REGIONAL REVIEW FINDING

Submitting Local Government: City of East Point
Name of Proposal: Cascade Acres

Review Type: Development of Regional Impact

Preliminary Report:	December 15, 2005	DEVELOPMENT OF REGIONAL IMPACT REVIEW REPORT	Project:	Cascade Acres #945
Final Report Due:	January 13, 2005		Comments Due By:	December 29, 2005

V/C Ratios (Ben Hill Road not shown)

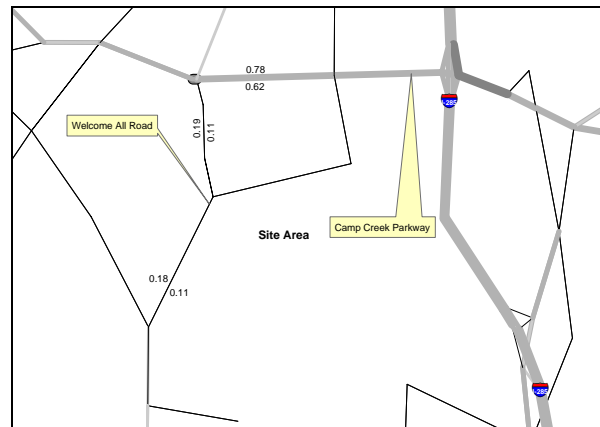
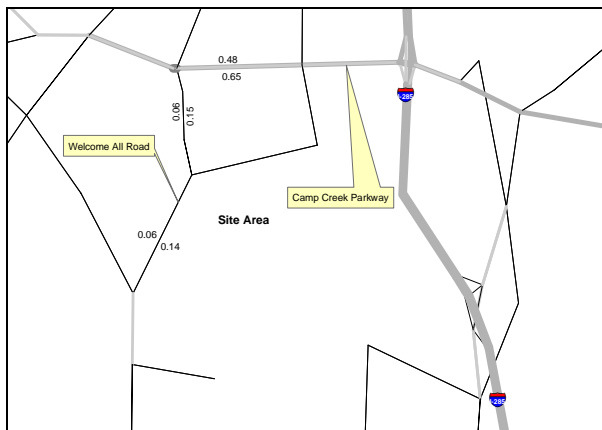
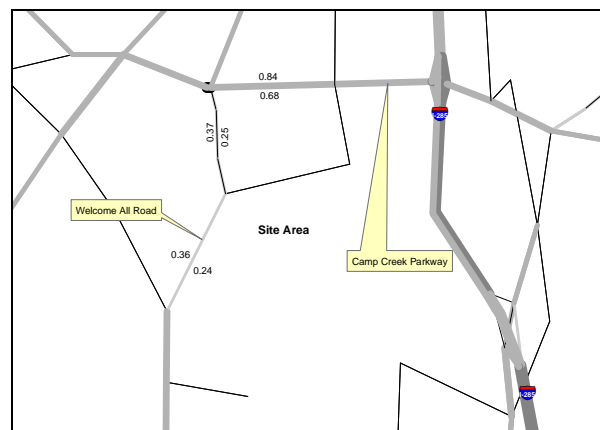
Incorporating the trip generation results, the transportation consultant distributed the traffic on the current roadway network. An assessment of the existing Level of Service (LOS) and projected LOS based on the trip distribution findings helps to determine the study network. The results of this exercise determined the study network, which has been approved by ARC and GRTA. If analysis of an intersection or roadway results in a substandard LOS "D", then the consultant recommends improvements.

Projected traffic volumes from the Regional Travel Demand Model are compared to the assigned capacity of facilities within the study network. This data is used to calculate a volume to capacity (V/C) ratio. The V/C ratio values that define the LOS thresholds vary depending on factors such as the type of terrain traversed and the percent of the road where passing is prohibited. LOS A is free-flow traffic from 0 to 0.3, LOS B is decreased free-flow from 0.31 to 0.5, LOS C is limited mobility from 0.51 to 0.75, LOS D is restricted mobility from 0.76 to 0.9, LOS E is at or near capacity from 0.91 to 1.00, and LOS F is breakdown flow with a V/C ratio of 1.01 or above. As a V/C ratio reaches 0.8, congestion increases. The V/C ratios for traffic in various network years are presented in the following table. Any facilities that have a V/C ratio of 1.0 or above are considered congested.

For the V/C ratio graphic, the data is based on 2005, 2010 and 2030 A.M./P.M. peak volume data generated from ARC's travel demand model for Mobility 2030, the 2030 RTP and the FY 2005-2010 TIP, approved in December 2004. The travel demand model incorporates lane addition improvements and updates to the network as appropriate. As the life of the RTP progresses, volume and/or V/C ratio data may appear inconsistent due to (1) effect of implementation of nearby new or expanded facilities or (2) impact of socio-economic data on facility types.

VICINITY MAP	DRAFT Information Based on 2008 Noise Exposure Contours	Hartsfield-Jackson Atlanta International Airport Department of Aviation
Cascade UMC	Legend	H-JAIA Planning & Development GIS TEAM
Legend	Legend	December 2005
Legend	Legend	December 2005

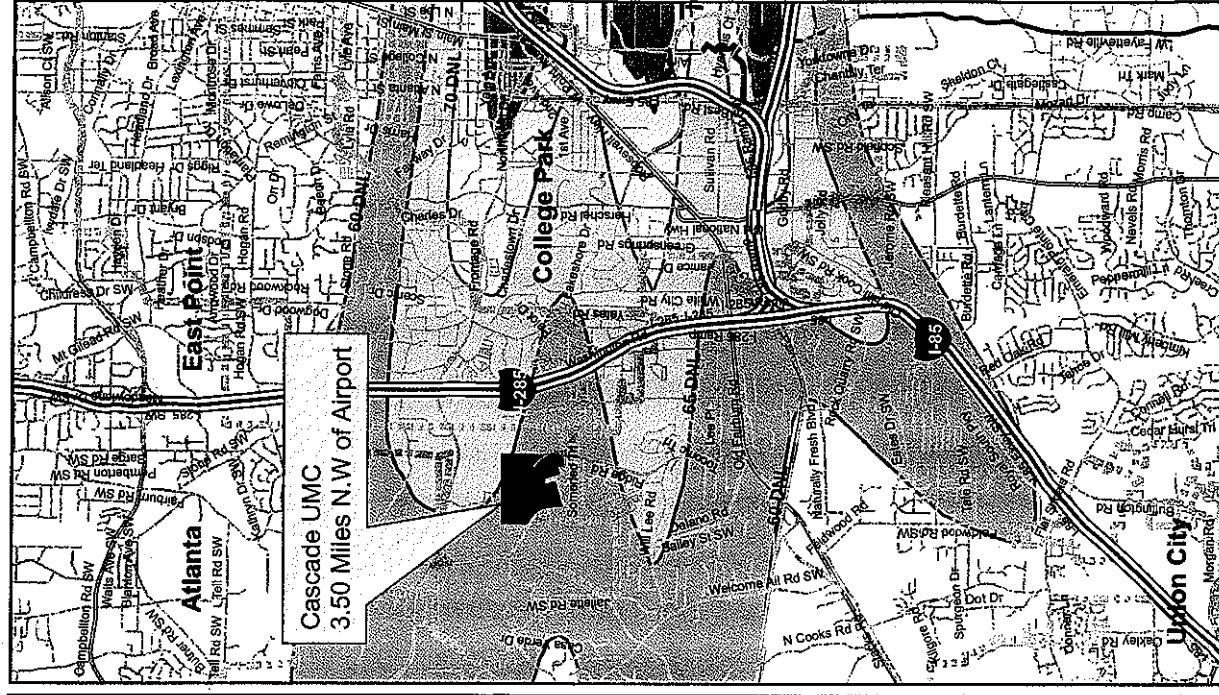
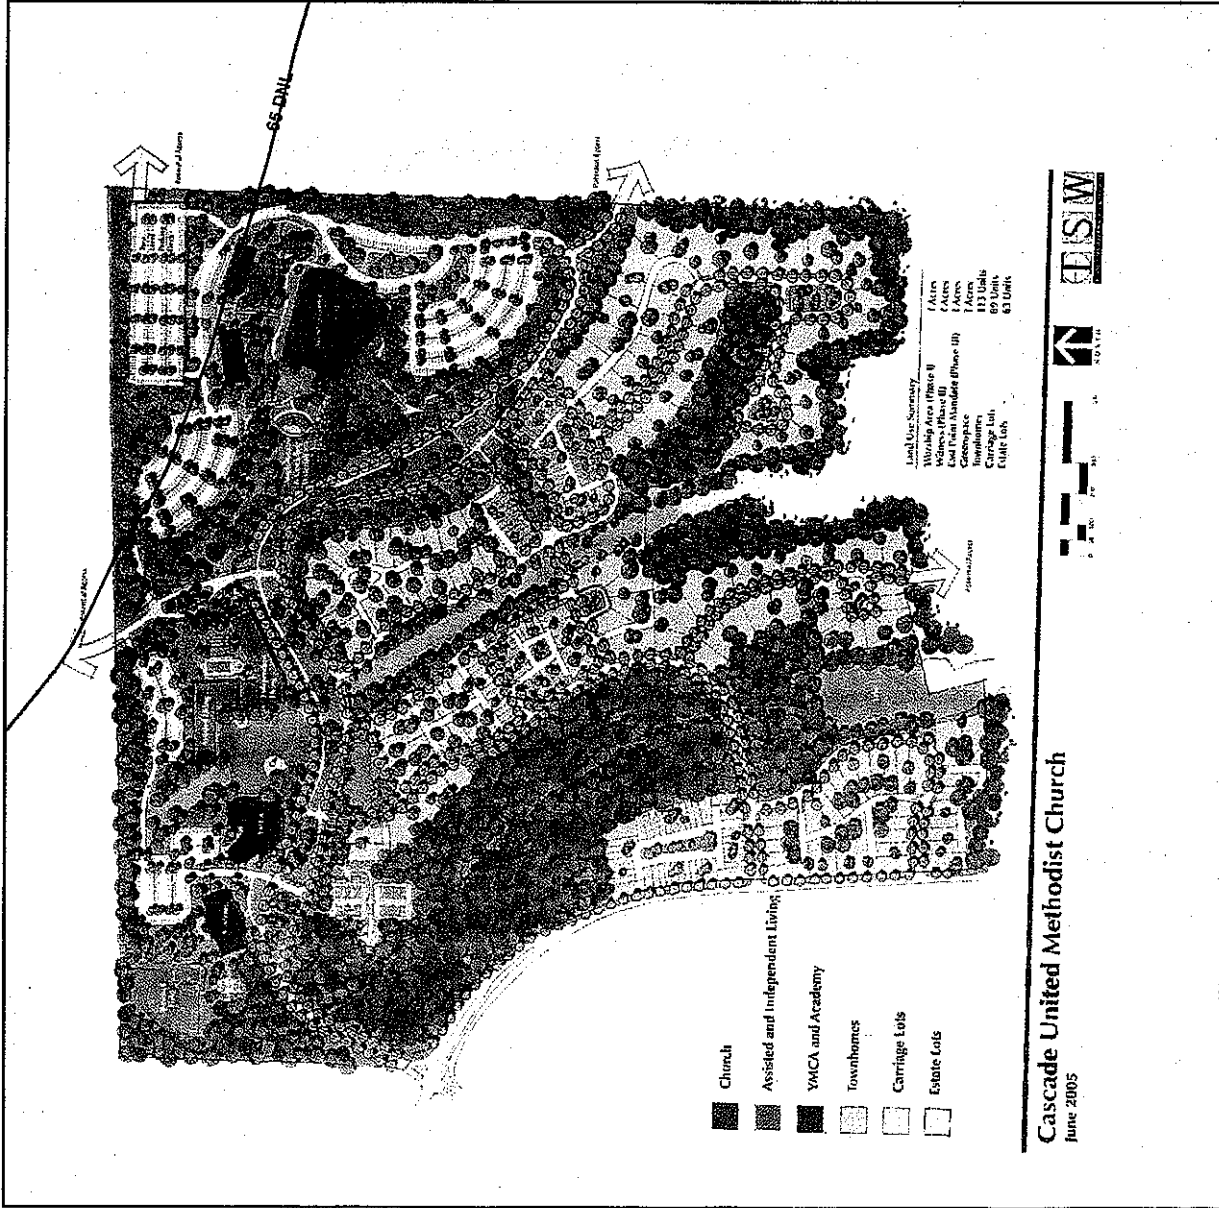
The proposed site is located approximately 3.5 miles west of the Hartsfield-Jackson Atlanta International Airport. As such, it is estimated that once the airport opens the new 5th runway, the majority of the development, with the exception of the northeastern section of the site, will lie between the 60 and 65 DNL noise contours associated with overall air traffic at the airport (see attached site plan). The remaining portion of the site lies between the 65 and 70 DNL noise contours. According to the Code of Federal Regulations Title 14, Part 150, **residential uses are deemed compatible between the 60 and 65 DNL noise contours**, while **residential uses are not deemed compatible between the 65 and 70 DNL contours**. However, where a community determines that residential uses must be allowed, measures to achieve outdoor-to-indoor noise reduction levels of 30 db should be incorporated into the structure.

MASTER PLAN for:

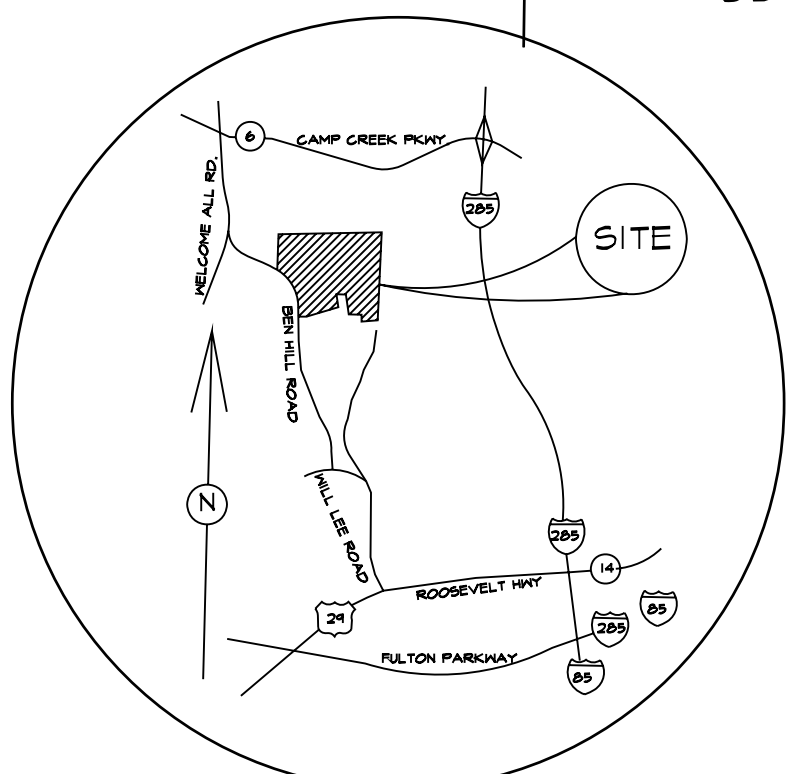
The proposed road network includes lanes or alleyways behind the single family homes for rear entry access. This allows for continuous street frontage and sidewalks along the roads. ARC encourages the use of alleyways throughout residential developments to encourage safe pedestrian travel throughout the development.

The proposed development includes greenspace and park amenities throughout the development. The dedicated park space is continuous throughout the development and connects to the active recreational uses proposed in the development. It is strongly encouraged that a trail be provided throughout the development to encourage residents to use alternative modes of transportation, such as walking and biking, to the various uses within the site. Trails should also provide external connections to adjacent properties for future continuous linkage throughout the area. Best Transportation Practice 10, listed below, encourages developments to provide shortcuts and alternatives for pedestrians and bicyclists to the main road and any high volume streets.

There are several double frontage lots along Ben Hill Road. ARC recommends that an adequate buffer is provided between the road and the proposed homes.
